HISTORIC AND DESIGN REVIEW COMMISSION

August 17, 2022

HDRC CASE NO: 2022-433
ADDRESS: 337 MADISON ST
LEGAL DESCRIPTION: NCB 743 BLK 2 LOT 10 & SW 16.7 FT OF 9
ZONING: RM-4
CITY COUNCIL DIST.: 1
DISTRICT: King William Historic District
APPLICANT: Cathy Spar/SPAR DENNIS & CATHY
OWNER: SPAR DENNIS & CATHY
TYPE OF WORK: Conceptual approval for addition of exterior elevator
APPLICATION RECEIVED: July 27, 2022
60-DAY REVIEW: Not applicable due to City Council Emergency Orders
CASE MANAGER: Jessica Anderson

The applicant is requesting conceptual approval to construct an exterior elevator.

**PROPOSED ELEVATOR
5'X5' FOOT PRINT
BOARD & BATTEN HARDI SIDING
PAINTED TO MATCH HOUSE
SCREENED BY EXISITNG VEGETAION**

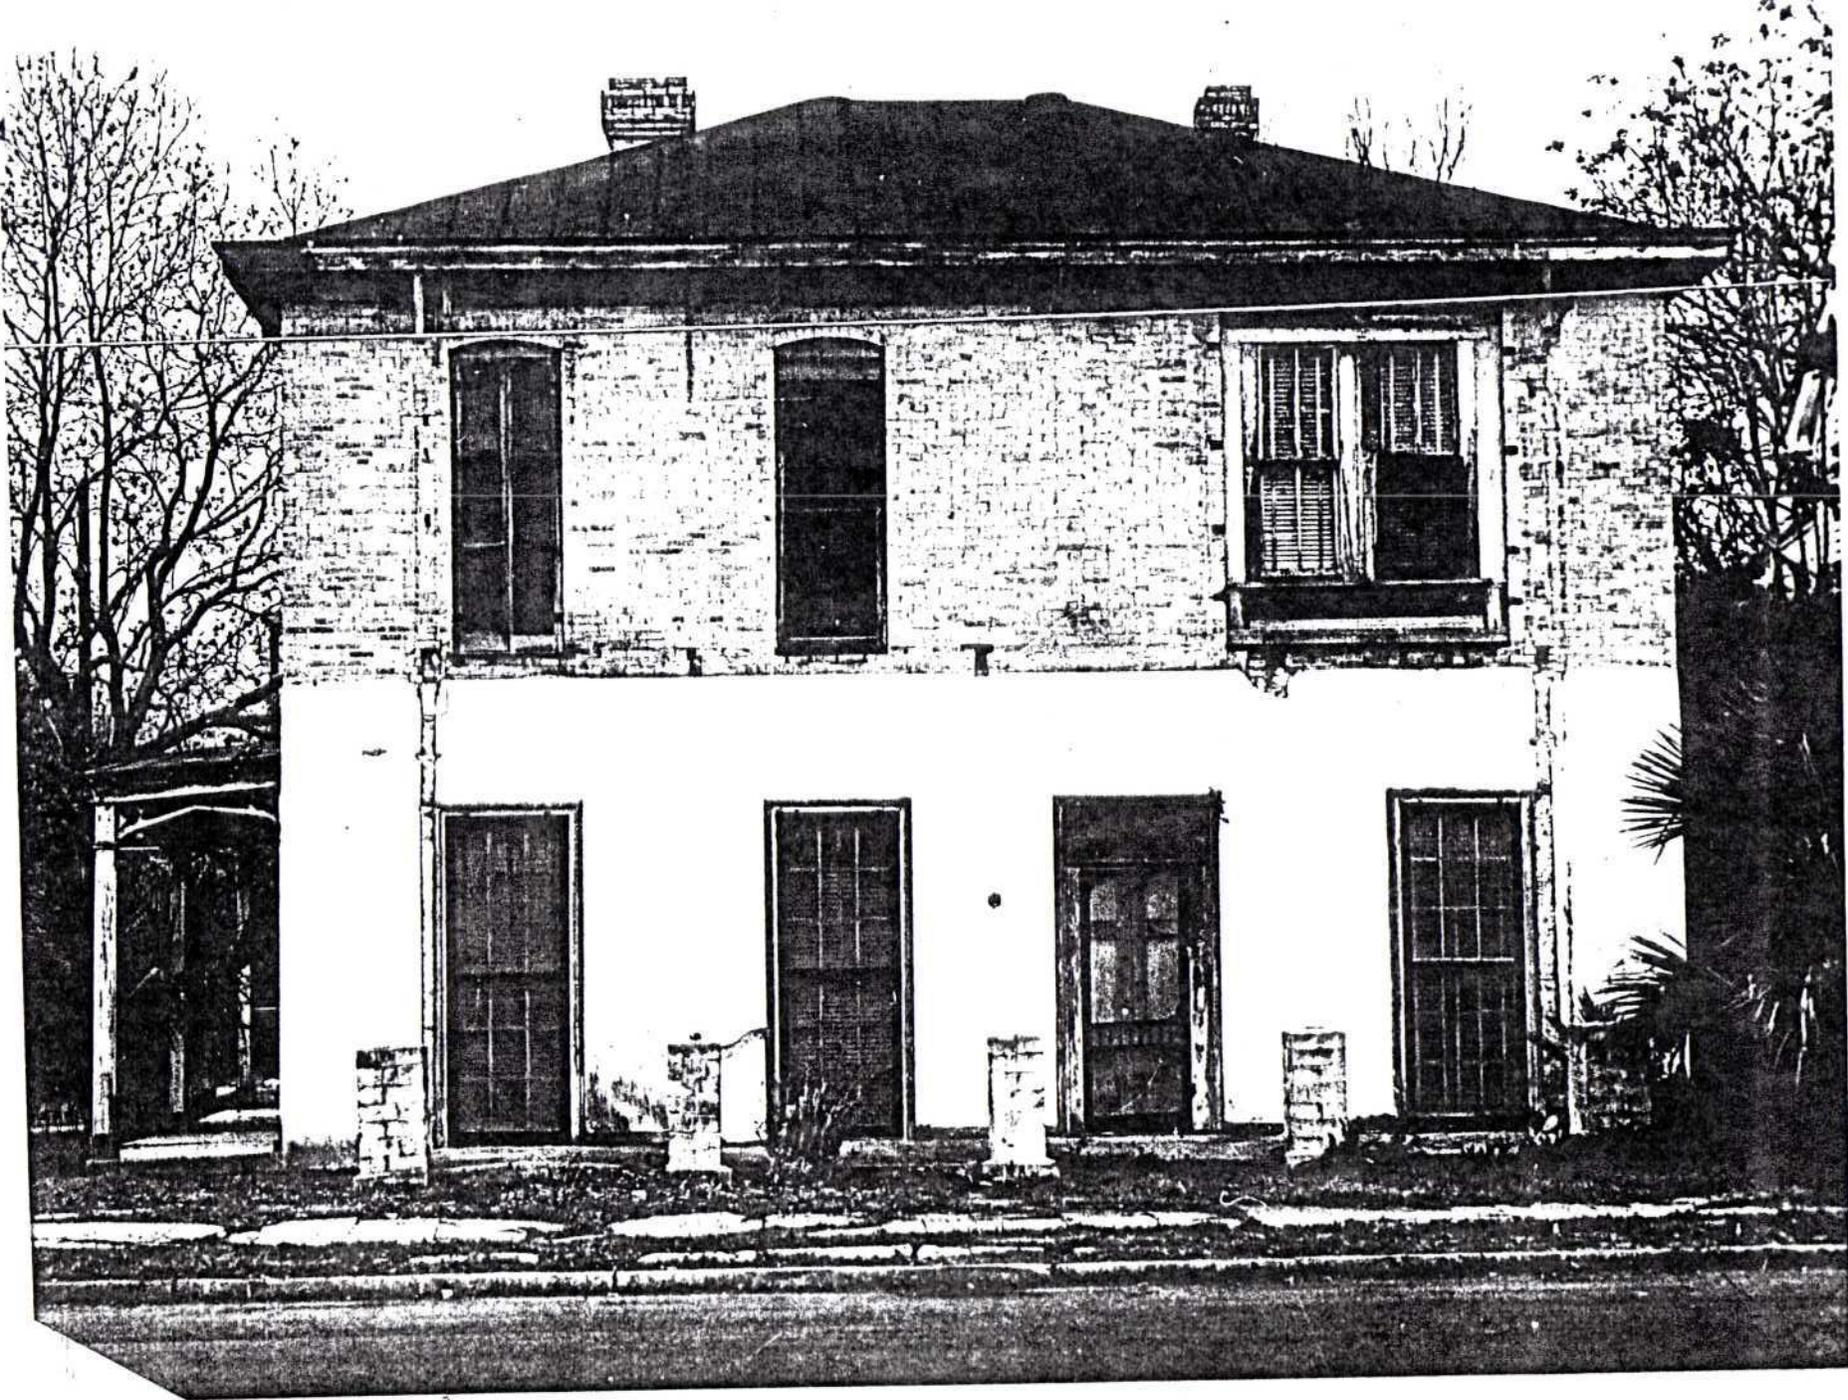
- b. VISUAL IMPACT: The applicant requests conceptual approval to add an exterior elevator to the northeast side of the house. The proposed addition is 5'x5' and clad in board and batten with a standing-seam metal shed roof. Guidelines for Additions 1.A.i says residential additions should be located at the side or rear of the building whenever possible to minimize views of the addition from the public right-of-way. Staff finds the proposed addition conforms to this guideline.

- c. SCALE, MASSING, AND FORM: The proposed exterior elevator is 5'x5' and clad in board and batten with a standing-seam metal shed roof. Guidelines for Additions, 1.B.i says residential additions should be subordinate to principal facades in scale and mass, and 1.B.iv and v state the proposed footprint and height should relate to the size of the lot. Staff finds the additional 25 square feet comprising the proposed addition conforms to these guidelines.

- d. MATERIALS AND TEXTURES: The applicant proposes an exterior elevator clad in board and batten with a standing-seam metal shed roof. Guidelines for Additions 3.A.i states that any new materials introduced to the site as a result of an addition must be compatible with the architectural style and materials of the original structure. Wood-frame Italianate homes of this era typically featured horizontal wood siding. Staff finds board and batten does not conform to guidelines.

- e. REVERSIBILITY: The applicant requests conceptual approval to add an exterior elevator to the northeast side of the house. The applicant confirmed by email that his plan is to punch new 40"-wide doorways through the stone wall at the first and second stories and reinforce the frame openings with structural steel since the walls are loadbearing. Staff is concerned about the reversibility of such an intervention. The Secretary of the Interior's Standards for Rehabilitation 9 and 10 state that additions and exterior alterations shall not destroy historic materials that characterize the property and that new additions shall be undertaken in such a manner that, if removed in future, the essential form and integrity of the historic property and its environment would be unimpaired. Because the introduction of new fenestration to accommodate the proposed elevator would result in an irreversible condition, namely the cutting of existing load-bearing stone members, staff finds the proposed addition does not conform to these guidelines

Staff does not recommend conceptual approval to construct an exterior elevator based on finding e. Staff recommends the applicant explore other options that do not include introducing new fenestration to the stone structure.
